SERVICE BULLETIN

ENGINE - LP COMPRESSOR - REWORK THE NO.1 BEARING AND NO.3 BEARING SEAL SEATS TO INCORPORATE AN INCREASED HARDFACE THICKNESS AND A REVISED SURFACE FINISH REQUIREMENT - CATEGORY CODE 6 - MOD.ENG-72-0090

V2500-ENG-72-0090

Location of No.1 Bearing Seal Seat
Fig.1

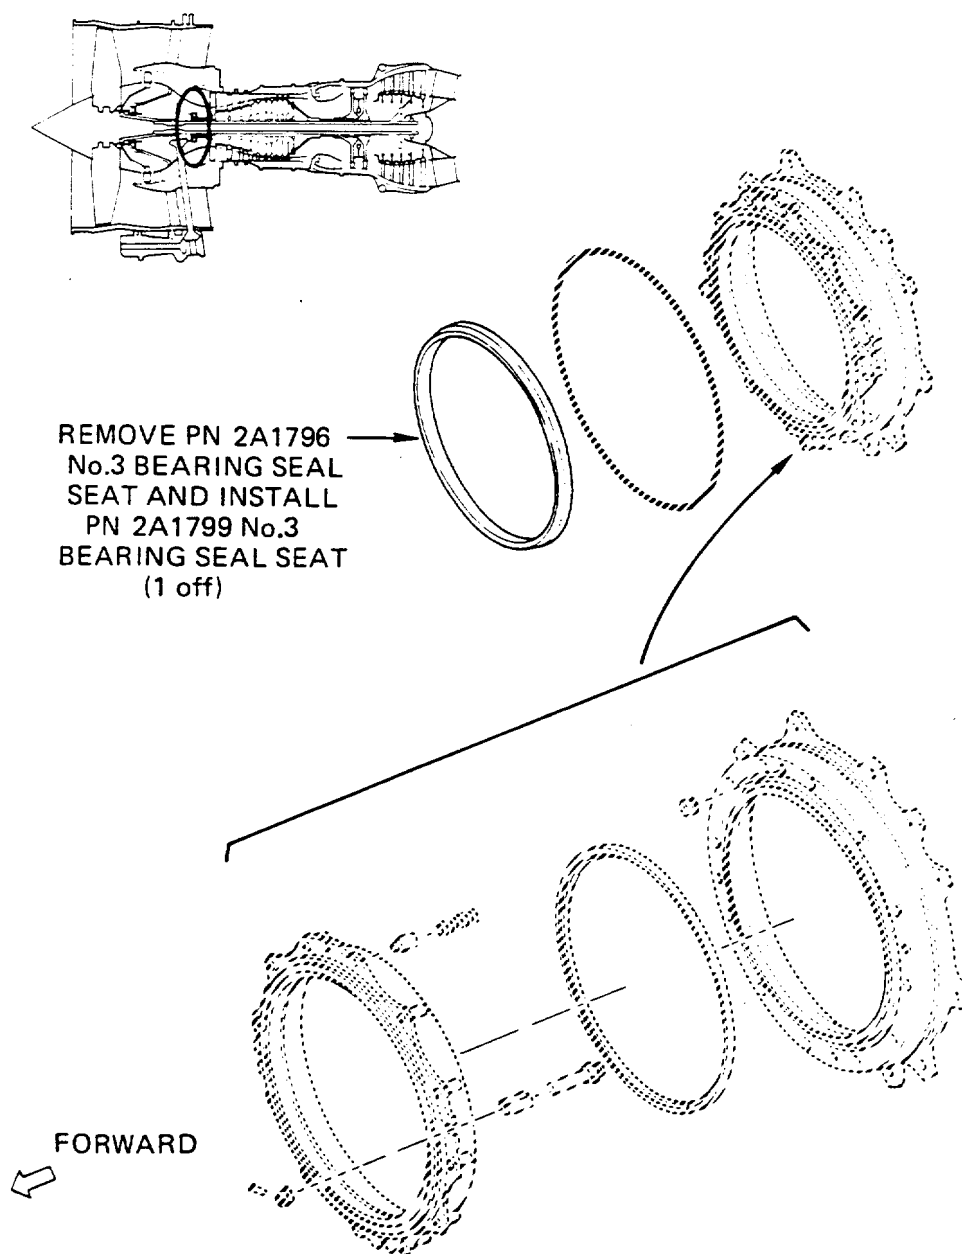
| Procedure | Supplementary Information | |
|--|---|-----------------|
| (a) Do an inspection of the No.1 Bearing Seal Seat | Refer to Figure 1. Refer to Reference (2), Chapter/Section 72-32-53, Inspection/Check-08 | |
| (b) If the hardface thickness and surface finish is in the limits specified identify with the new part number adjacent to the old part number. Use the vibration peen method | Old Part Number | New Part Number |

Location of No.3 Bearing Seal Seat
Fig.2

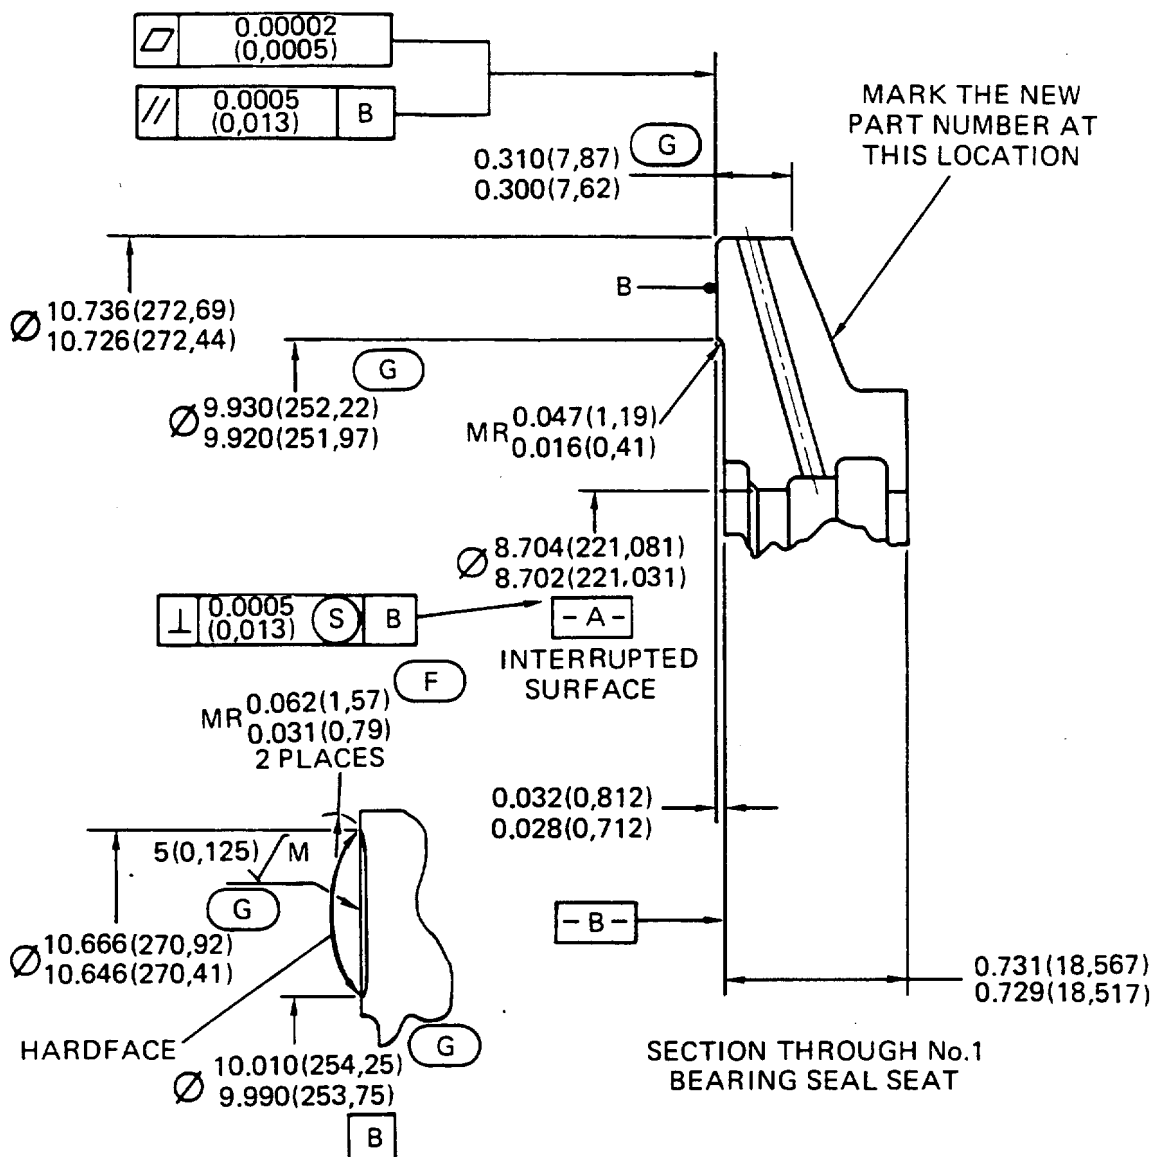
| Procedure | Supplementary Information | |
|--|---|-----------------|
| (a) Do an inspection of the No.3 Bearing Seal Seat | Refer to Figure 2. Refer to Reference (2), Chapter/Section 72-32-25, Inspection/Check-08 | |
| (b) If the hardface thickness and surface finish is in the limits specified identify with the new part number adjacent to the old part number. Use the vibration peen method | Old Part Number | New Part Number |

Modification of No.1 Bearing Seal Seat
Fig.3

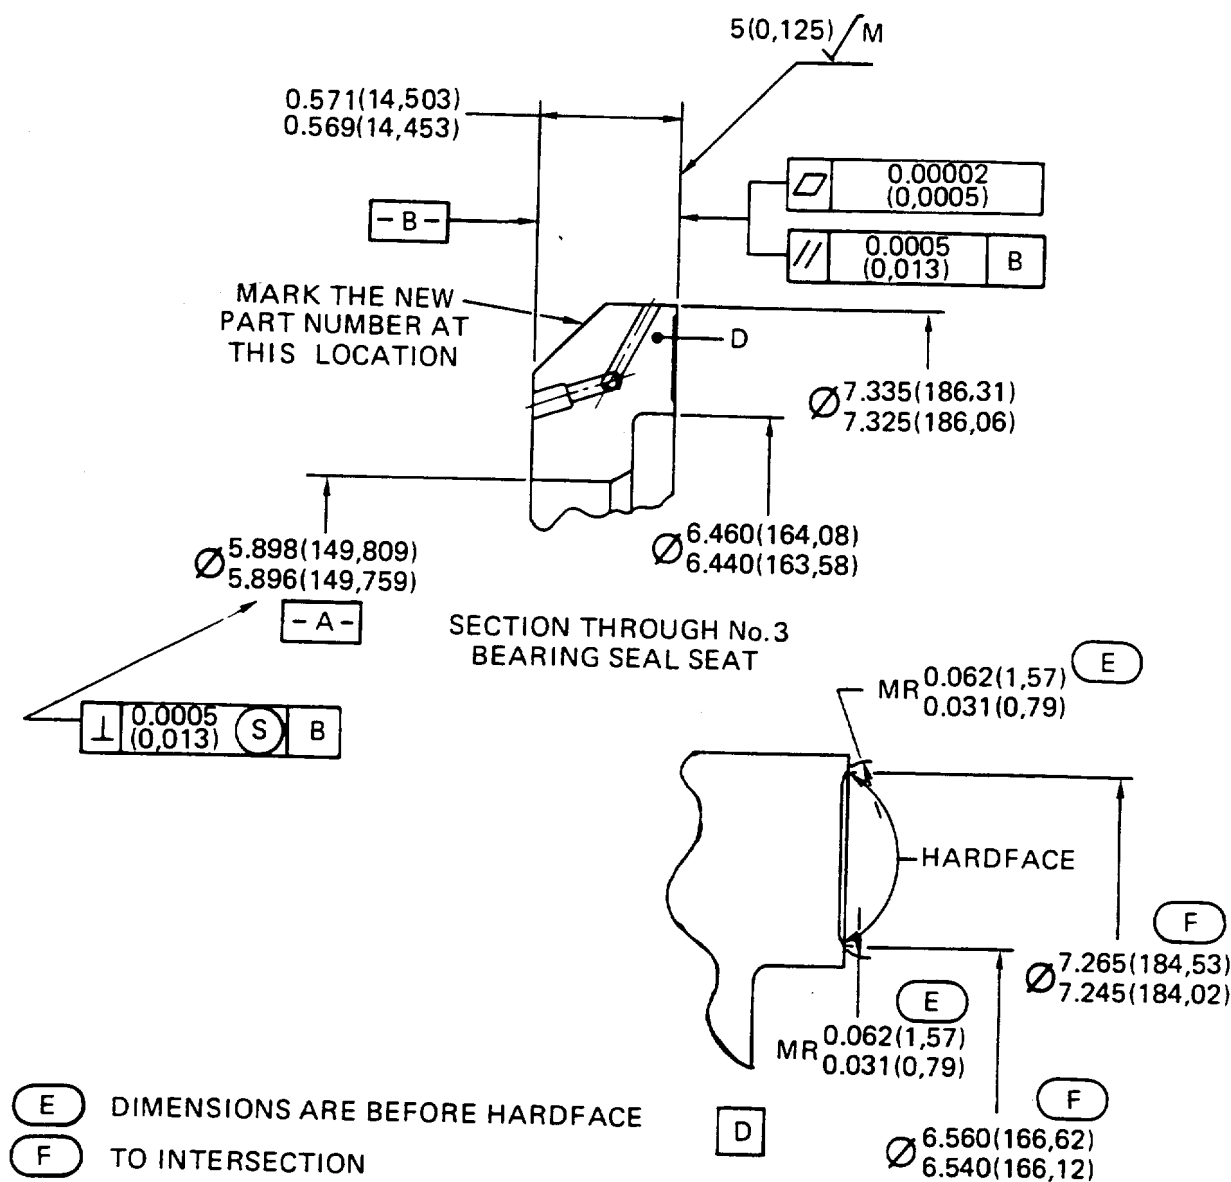
| Procedure | Supplementary Information | |
|--|--|--|
| (i) Set-up and machine the No.1 Bearing Seal Seat | Refer to Figure 3 | |
| (ii) Hardface the enclosed area (view B) with chromium carbide coating. Overspray is not permitted | Refer to Figure 3, requirements, for coating location. Apply coating by the approved procedure in Reference (3), Control No./Task No. 70-34-02-340-501 | |

| (iii) Set-up and machine to dimensions and surface finish specified | Refer to Figure 3, requirements and Reference (3), Control No./Task No.70-35-09-350-501 | |

(F) DIMENSIONS ARE BEFORE HARDFACE

NOTE : UNLESS DIFFERENTLY SPECIFIED DIMENSIONS ARE AFTER HARDFACE
